PRODUCT CHANGE NOTIFICATION

Bourns® Model CDSOT23-SR208 Steering Diode Array and CDSOT23-SRV05-4 Steering Diode TVS Array Combo

Addition of Manufacturing Site

Typical Part Marking

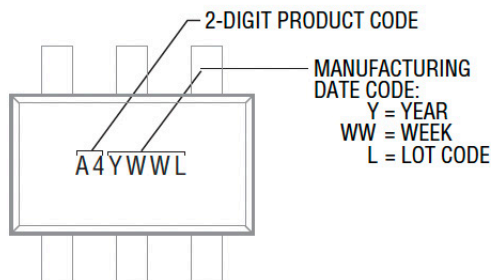
The Si fabrication and the assembly process will not change at this new additional assembly and test manufacturing site. The assembly process at the new site will change slightly because the interconnect material used at this new site will be changed from gold to copper, and the terminal finish will be changed from NiPdAu pre-plating to 100 % tin plating. These changes have been fully qualified and will have no impact on the fit or function of the affected part numbers. The part marking will be used to identify units produced at the new additional assembly and test manufacturing site. The lot code (L) of the new site will follow alphabetic characters while the current site will continue to use numbers.

The form of the part numbers made at the new additional manufacturing site will change due to the material changes described above and because of a small change in the part marking for traceability purposes. The quality, reliability and performance of the overvoltage protectors produced at the new manufacturing site will be the same as those from the existing plant. The production lead times of these overvoltage protectors should improve gradually as our capacity is expanded. The country of origin will remain the same.
